The sample metal box made for Mr. Reber last month has been tested and found satisfactory with the following alterations.

We are pleased to submit the following
quotation for metal boxes with alternatives as requested.

LAYOUT
1/4 SIZE

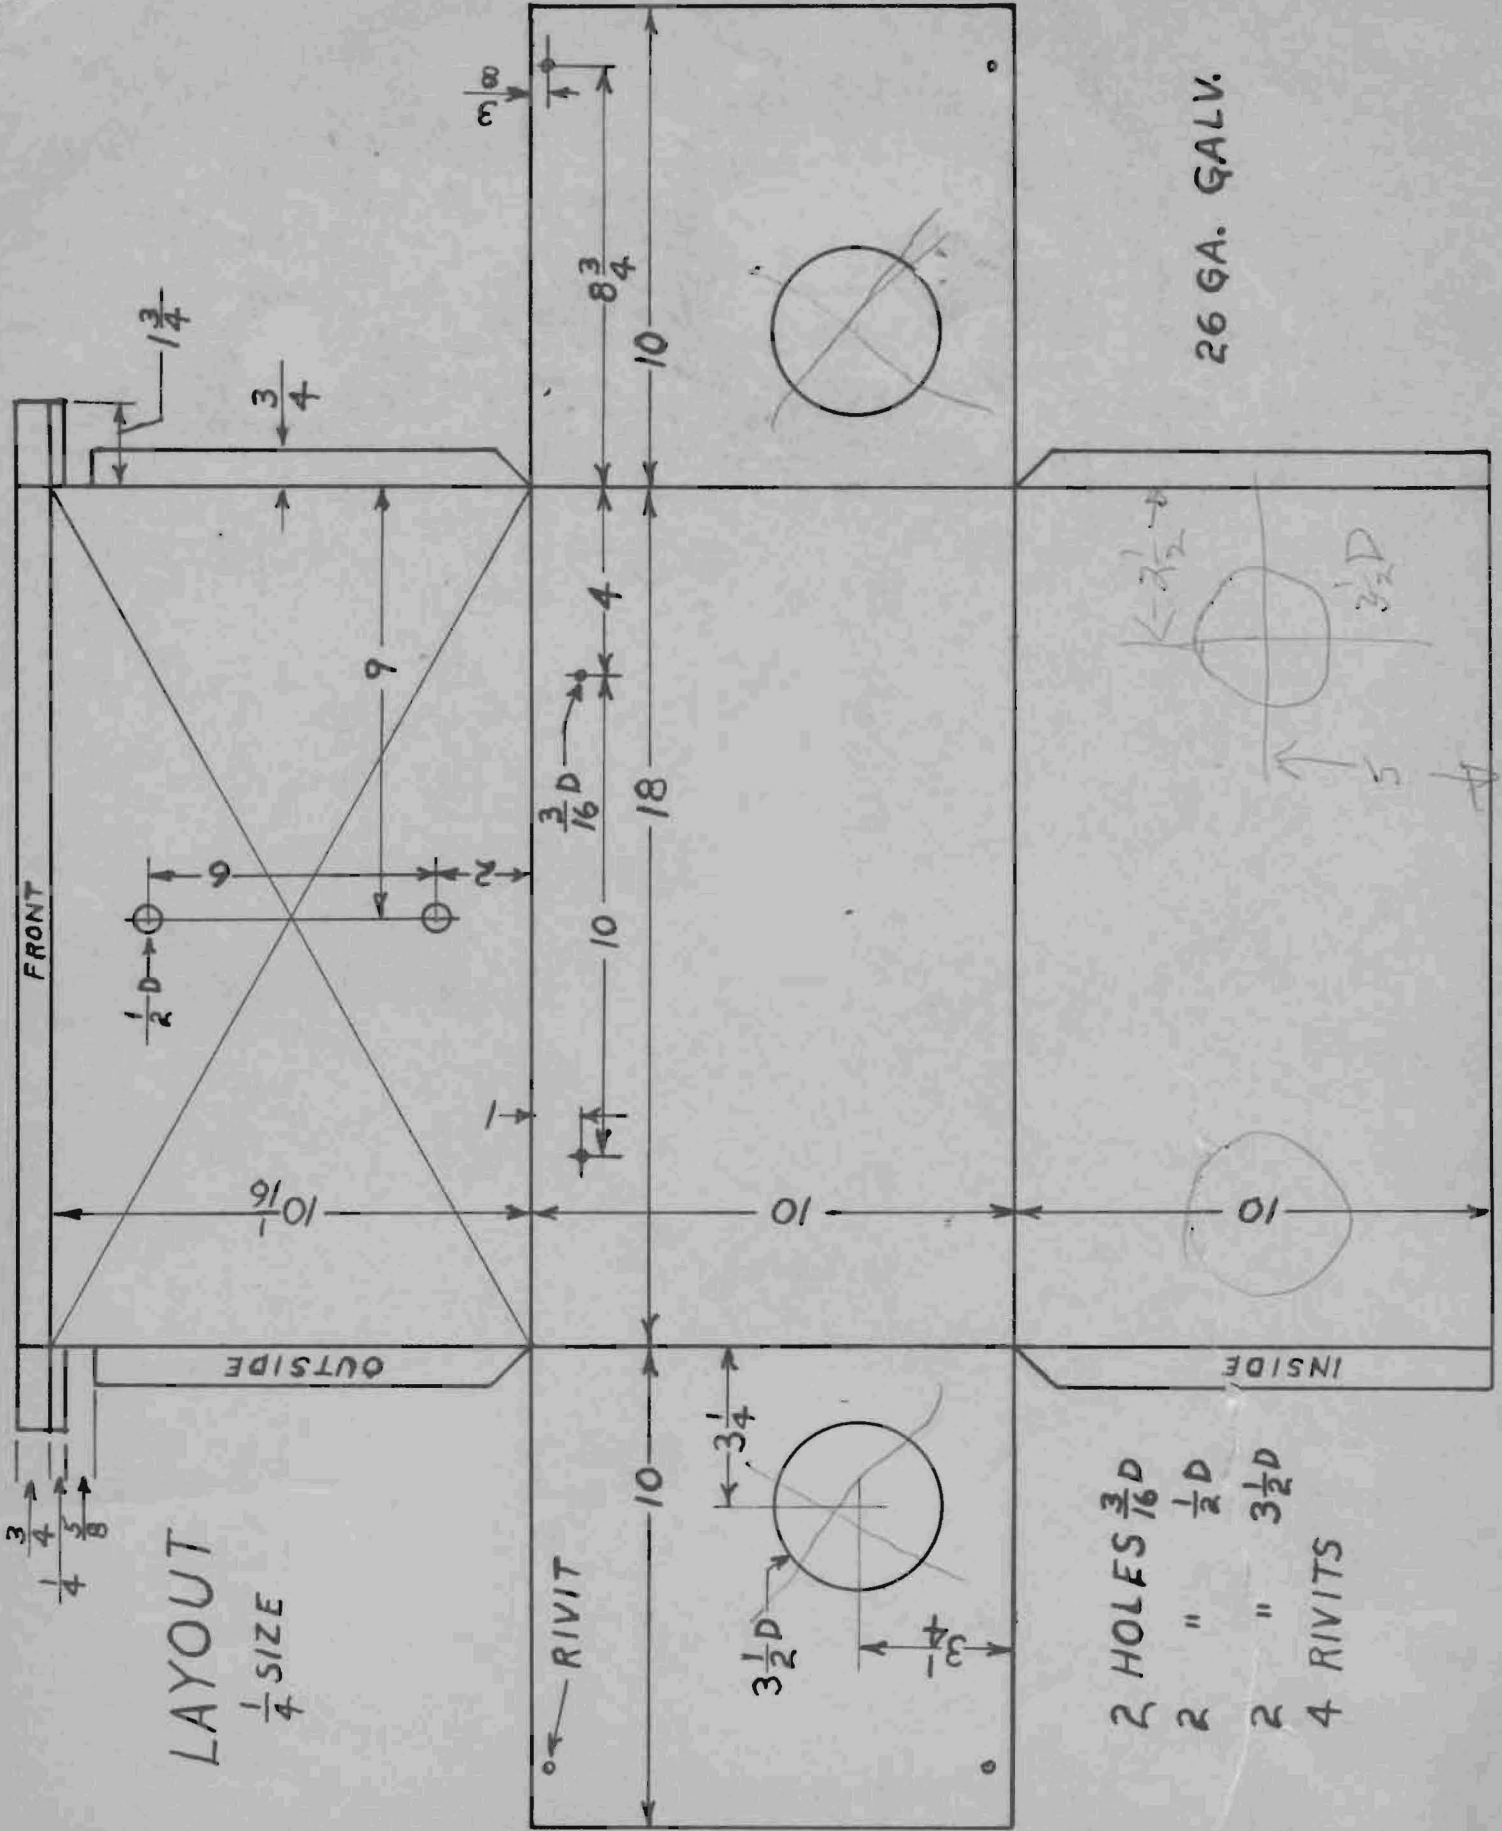
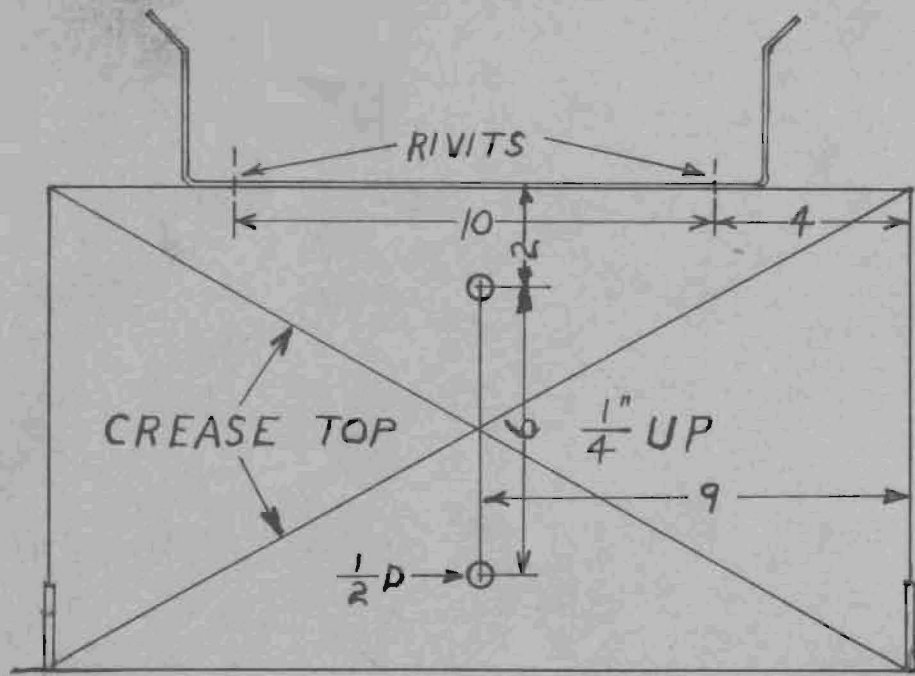
1. Increase lip at bottom from $\frac{1}{4}$ " to $\frac{1}{2}$ " and size of cover appropriately.
2. Close corner slots on back of cover at top by folding top lip over sides or by soldered triangular patch.
3. Holes on top to be drilled $\frac{15}{32}$ " dia. by suitable bit to produce clean edge. Bit provided by C.S.I.R.O.
4. Drill with similar bit a $\frac{1}{4}$ " hole in back centre at 1" above bottom.
5. Fasten on back by two rivets spaced 10" apart and 1" down from top, a bracket supplied by C.S.I.R.O.,
6. One $\frac{5}{32}$ " dia. hole in centre of each end.
7. Four $\frac{5}{32}$ " holes at corners of 3" square centred on $3\frac{1}{2}$ " holes in bottom. Make accurate drilling template to fit into $3\frac{1}{2}$ " holes to insure uniformity.

COUPLER BOX

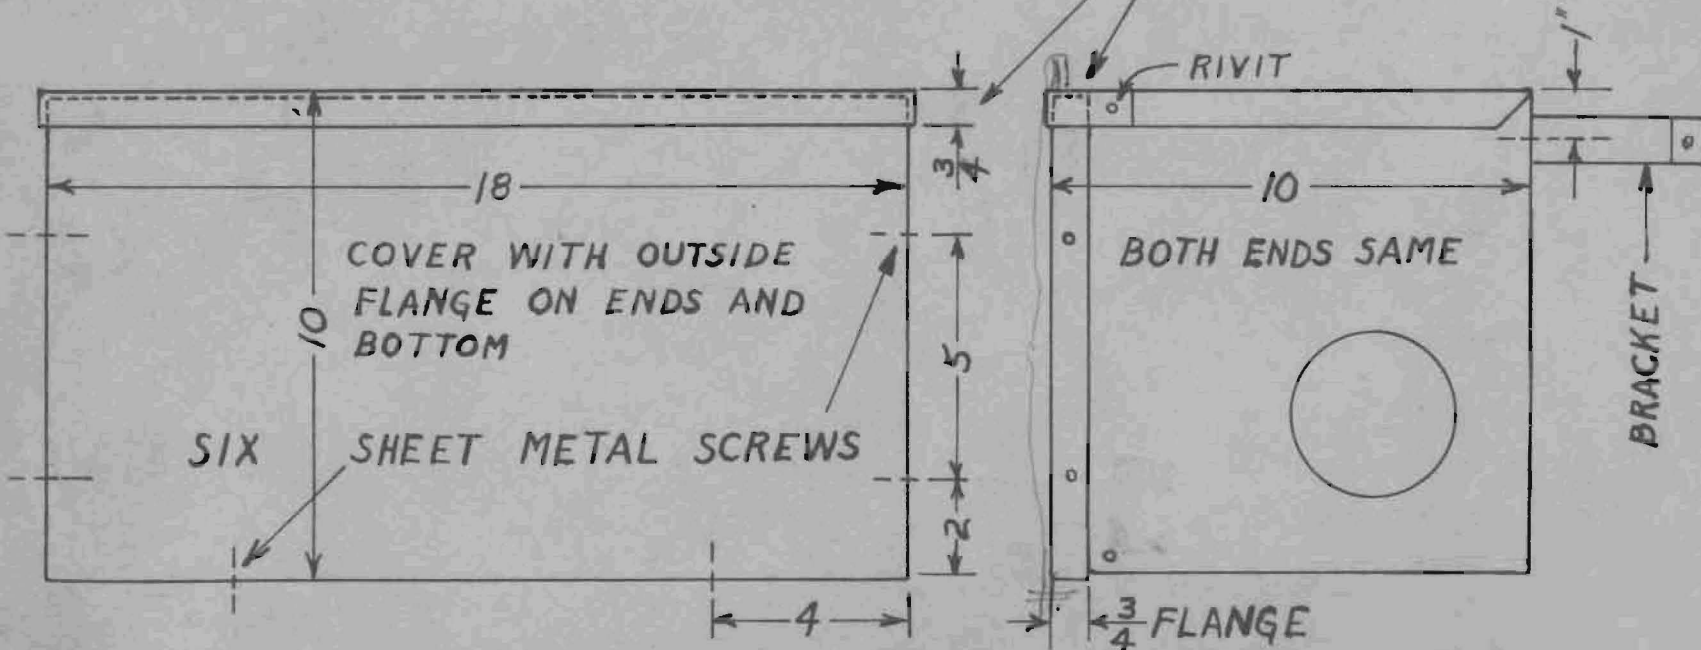
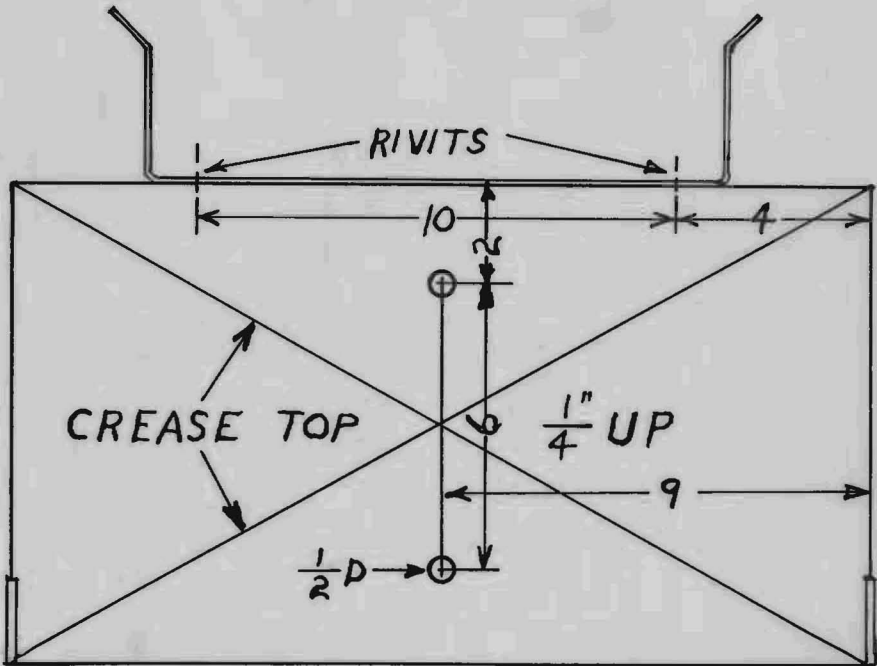
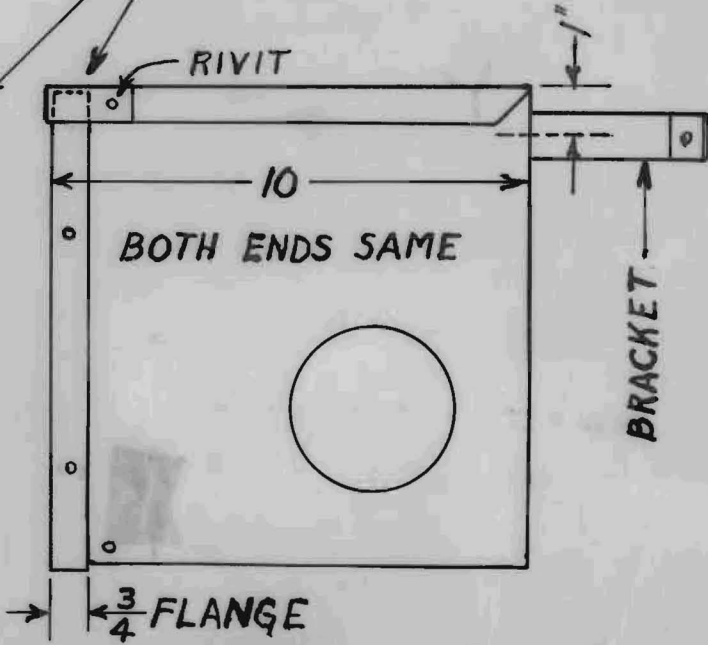
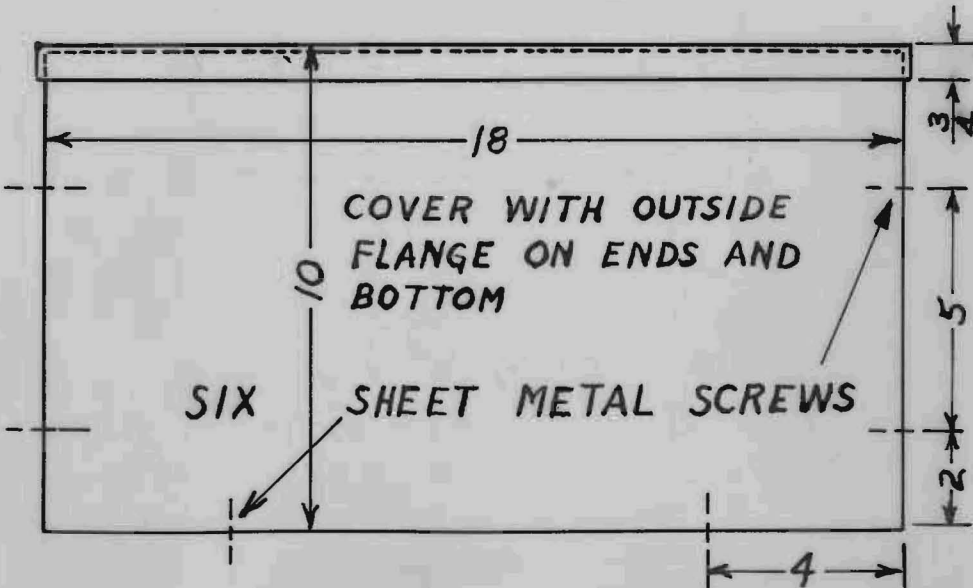
FLANGE WITH TIGHT CORNERS OVER COVER
